1 Redline Revision
Dated May 18, 2011

MD 5 (THREE NOTCH ROAD)
AND MECHANICVILLE ROAD
MECHANICVILLE, MARYLAND

TRAFFIC SIGNAL PLAN			
SCALE	1" = 20'	DATE	January 22, 1998
CONTRACT NO.	AW2795185		
DESIGNED BY	K. Waller	COUNTY	St. Mary's
DRAWN BY	D. Doda	LOGMILE	18005040.25
CHECKED BY	D. Doda	TMS NO.	D-929
F.A.P. NO.	AC-STPG-000S(590)E	TOD NO.	
TS NO. 3760B	DRAWING NO. 1 OF 2	SHEET NO. OF

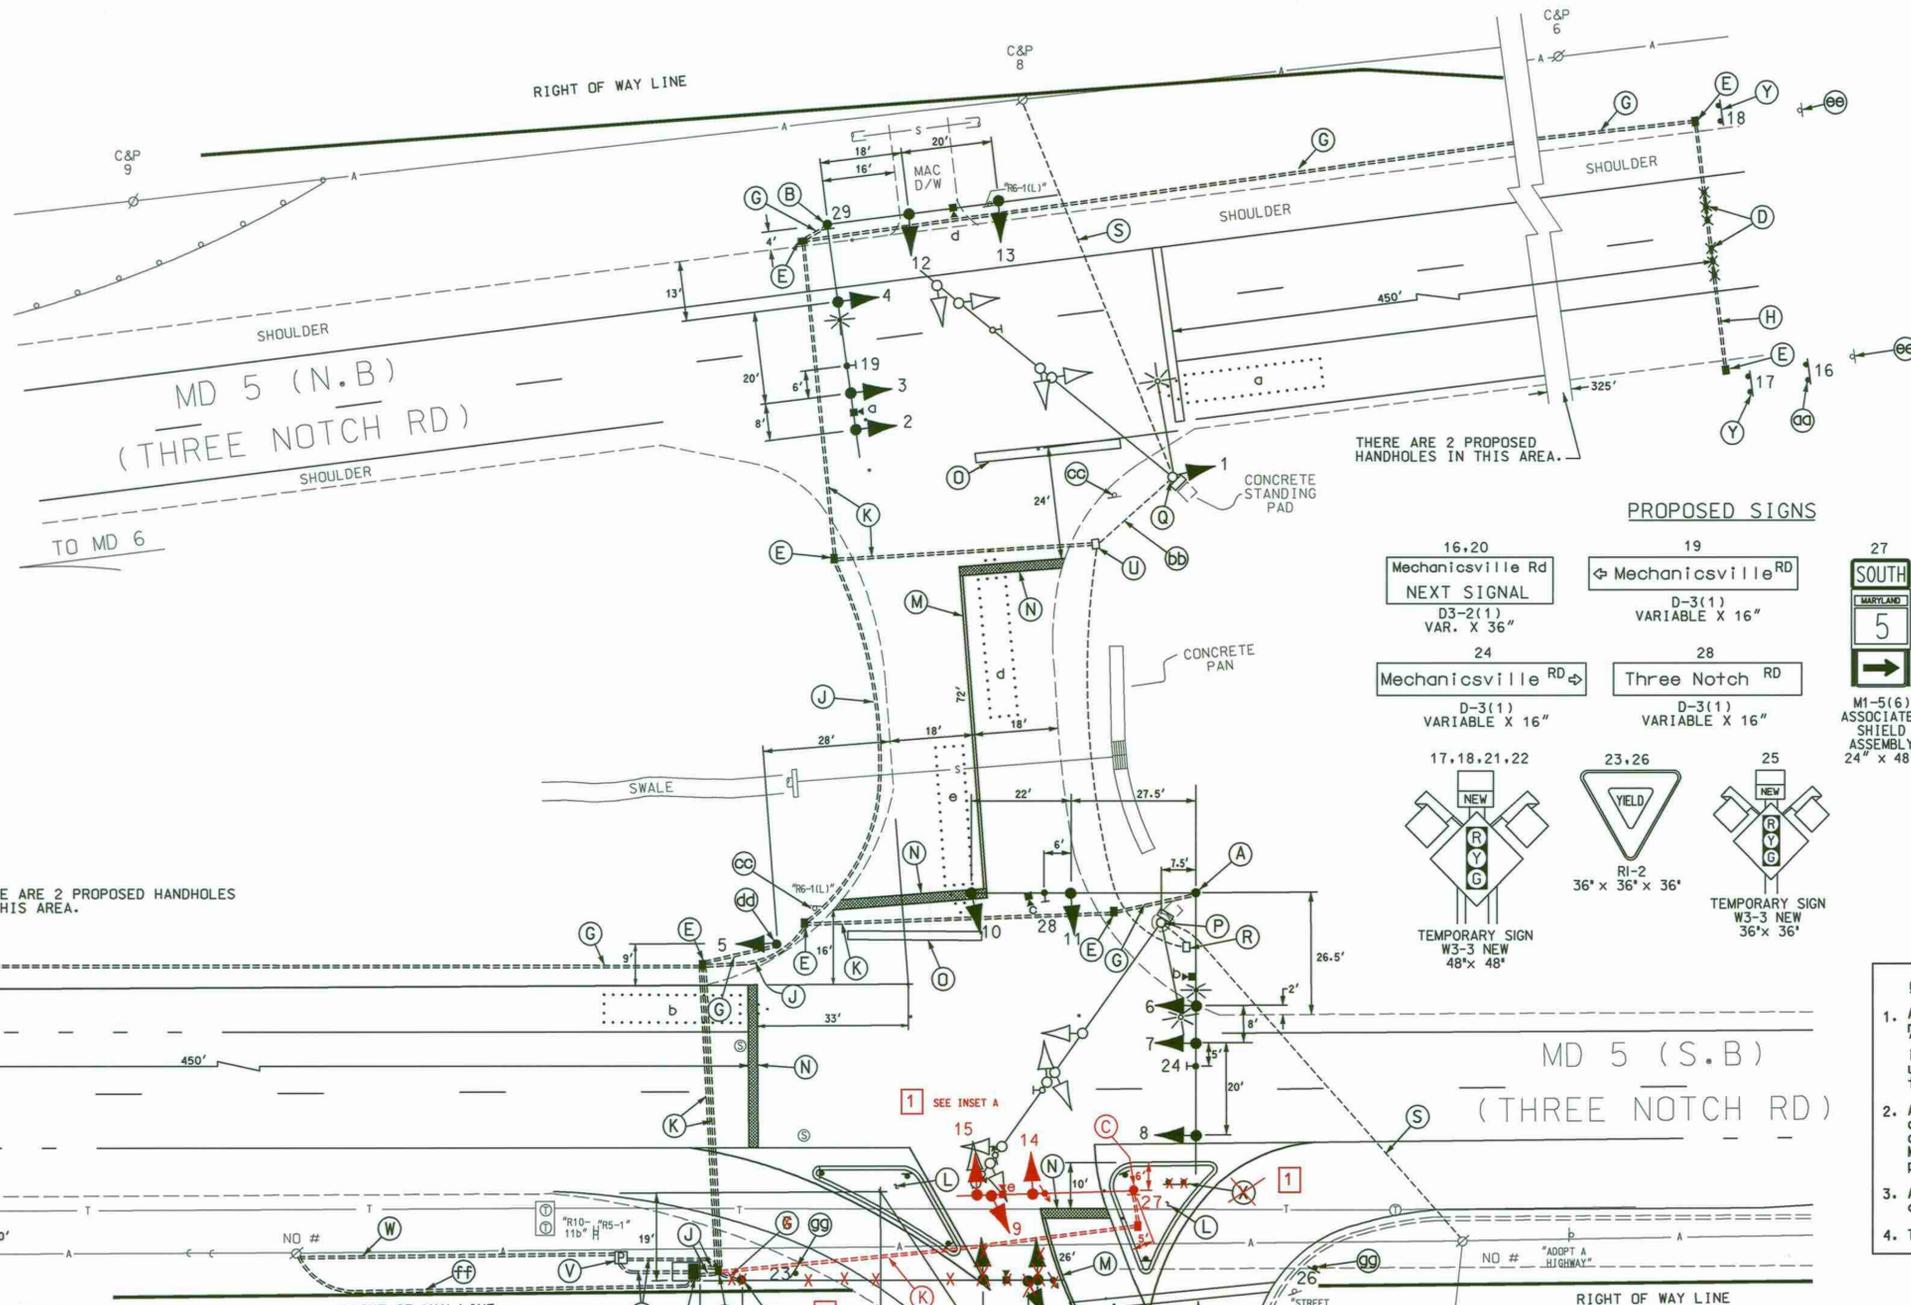
REVISIONS	
⑥ 1/14/2010	UPGRADE TO FULLY ACTUATED FULL COLOR SIGNAL S.H.A. No.: XX4475185 TMS: K565 RRZ
A	Add NB MD 5 indications. S.H.A. No.: X21005585 jlr KW DJD DZ T.H.
